## Service Product Report Forms

## Changes in "Mechanical Specifications and Adjustments"

23rd Series

## Intake Manifold Drain for Custom Eights

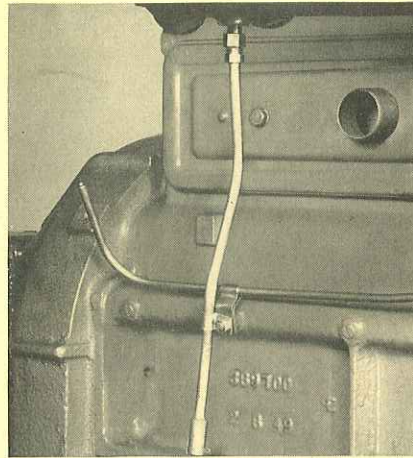
An intake manifold drain valve is now being installed on all Custom Eight engines in production. This valve may be installed on 22nd Series Custom Eights and all prior model Super Eights. It is located at the rear of the manifold for the purpose of draining accumulated fuel from the manifold. In some cases of hard starting fuel settles and accumulates at the rear of the manifold adjacent to numbers 7 and 8 intake ports.

When this condition exists this fuel sometimes enters the cylinder and since it is not compressible causes damage to the piston or connecting rod on the compression stroke.

The valve may be installed on cars not so equipped by drilling the manifold at the point shown in the illustration and tapping with a standard  $\frac{1}{8}$  pipe tap. The manifold should not be tapped deeply since the connector should be as near flush with the inside of the manifold as possible.

The valve is supported by a clip attached to a special pipe plug stud installed in the second oil gallery plug hole from the rear of the gallery.

The necessary parts for this installation are as follows:

## Overdrive Free Wheel Roller Retainers

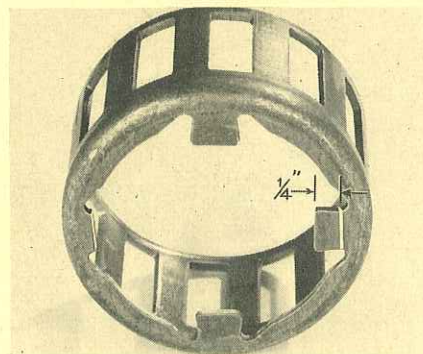
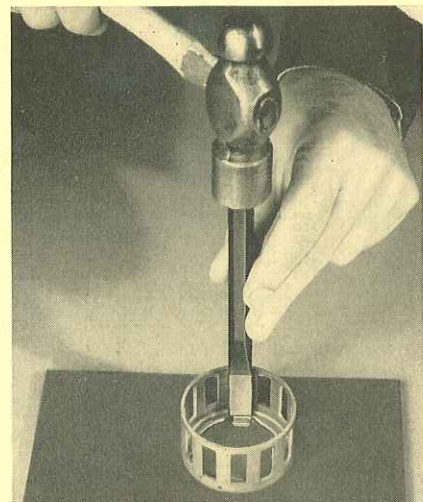
Free wheel roller retainers for the R-11 overdrive now are being shipped from the Factory as service replacement retainers for R-9 overdrives of the four pinion type. These retainers are carried under part number 347580.

Retainers for the four pinion type R-9 overdrives also were carried under part number 347580 before the adoption of the R-11 unit. However, these retainers differed from those now being shipped in that four stops or tabs were used whereas the present retainer has only two.

These early (four tab) type retainers in Dealer stock may be used in R-11 overdrives after removing the two tabs which are near the retainer spring holes.

To remove the tabs, place the retainer on a hard, flat surface and, using a cold chisel, cut the tab off  $\frac{1}{4}$  inch from its end and repeat the operation on the opposite side. The sharp edges in the retainer then should be filed flat as shown.
